SPB Number: 2022.0103

FINISH UPDATES

Issued: 05/13/2022

STANDARD PLAN BULLETIN NOTICE
RaceTrac Engineering and Construction Division

- Sheet: A000
- Attachments: A000

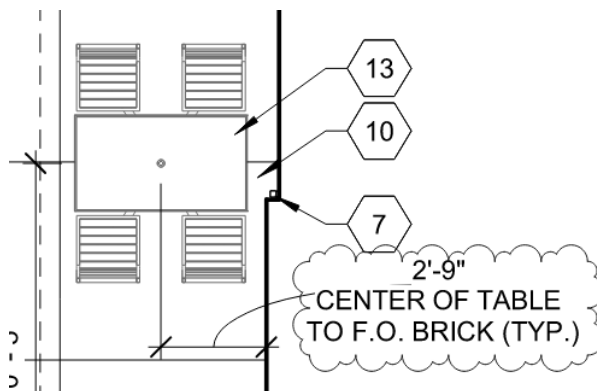
- REGIONAL BRICK UPDATES:** Updated the vendor and contact information for Brick under national account vendor list to be US Brick for GA/TX/LA/TN/FL and added designer note to change brick vendor to General Shale for KY, IN & OH.

2	BRICK	US BRICK	CARL KEENUM CKEENUM@USBRICK.COM	M: (256) 759-7600		DESIGNER NOTE: CHANGE VENDOR TO GENERAL SHALE AND CONTACT TO JAKE BRADFORD, JAKEBRADFORD@MERIDIANBRICK.COM, 404-694-8538, FOR KY, IN & OH STORES ONLY.
3	FINISH HARDWARE	LOCKNET	JEFF KIRKNER	O: (800) 887-4307 EXTENSION: 131	100 COURCHELLE DR. NICHOLASVILLE, KY 40356	
4	CERAMIC TILE AND BASE *	DALTILE *	TERRIE MILLER	M: (877) 556-5728 M: (214) 300-3408	RACETRAC@DAL TILE.COM

- Sheet: A130
- Attachments: A130

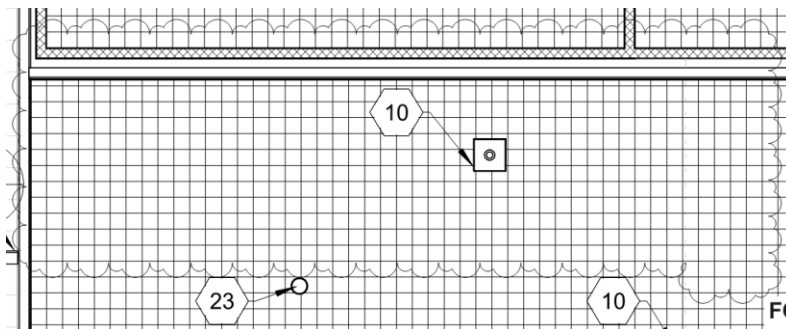
7. **FLOOR TILE STRIPING:** Remove painted striping layout over tile at the chicken area.

14 DETAIL - HEAD 04
 1 1/2" = 1'-0"

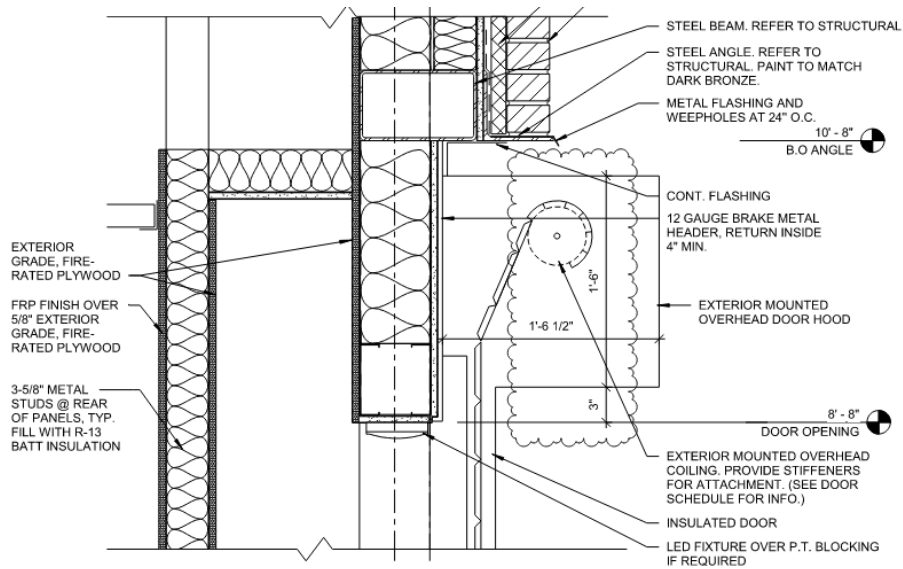
8. **ROLLUP DOOR:** Updated the rollup door manufacturer, Florida Product Approval, and detail.
